Access Compliance Report

Public Rights-of-Way

Intersection ID: 49322	Main Street: OLD_HOUSE_CR	Cross Street: WHITEBEAM_WY	Location: NW
ADA ID: 69A2FAE32C60	Ramp Type: PerpDiag	Initial Pass/Fail: Fail	Overall Compliance: No
		Severity Score: 10

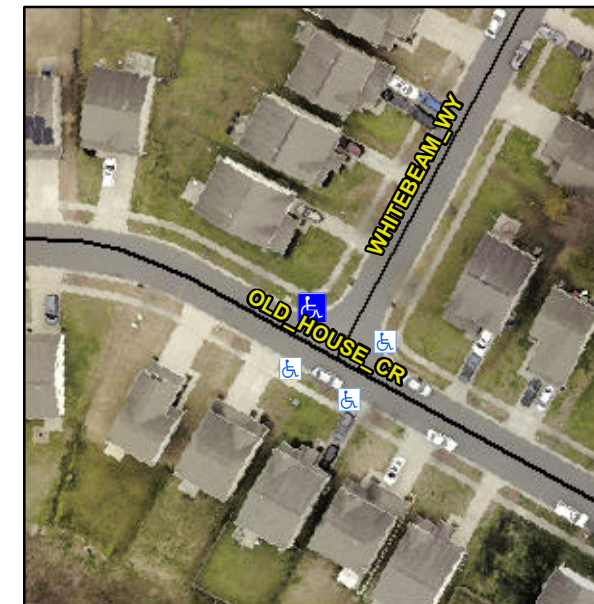
Not Found, R304.5.1, R304.5.3

Compliance	Description	Data	Compliance	Description	Data
N/A	Ramp Length (in)	71.5	Yes	Ramp Slope (%)	5.3
No	Ramp Width (in)	38.0	No	Ramp XSlope (%)	3.3
N/A	Flare Type LT	N/A	N/A	Flare Type RT	N/A
N/A	Flare Slope LT (%)	N/A	N/A	Flare Slope RT (%)	N/A
N/A	Flare Traversable LT?	N/A	N/A	Flare Traversable RT?	N/A
N/A	Landing Length (in)	N/A	N/A	DWS Provided?	N/A
N/A	Landing Width (in)	N/A	N/A	DWS Contrast?	N/A
N/A	Landing Slope (%)	N/A	N/A	DWS Length (in)	N/A
N/A	Landing X Slope (%)	N/A	N/A	DWS Full Width?	N/A
N/A	Landing Curb? (Y/N)	N/A	N/A	DWS Offset (in)	N/A
N/A	Shared Landing?	N/A			
N/A	Gutter Ponding?	N/A	N/A	Gutter Slope (%)	N/A
N/A	Gutter Lip Ht (in)	N/A	N/A	Gutter X Slope (%)	N/A
N/A	Painted X Walk1?	No	N/A	Painted X Walk2?	No
	X Walk 1 Direction	To SW		X Walk 2 Direction	To SE
N/A	X Walk 1 Width (in)	N/A	N/A	X Walk 2 Width (in)	N/A
	X Walk 1 Slope (%)	0.9		X Walk 2 Slope (%)	2.6
	X Walk 1 X Slope (%)	3.0		X Walk 2 X Slope (%)	0.6

Remove & Replace Curb Ramp With Two New Directional Ramps or Equivalent.
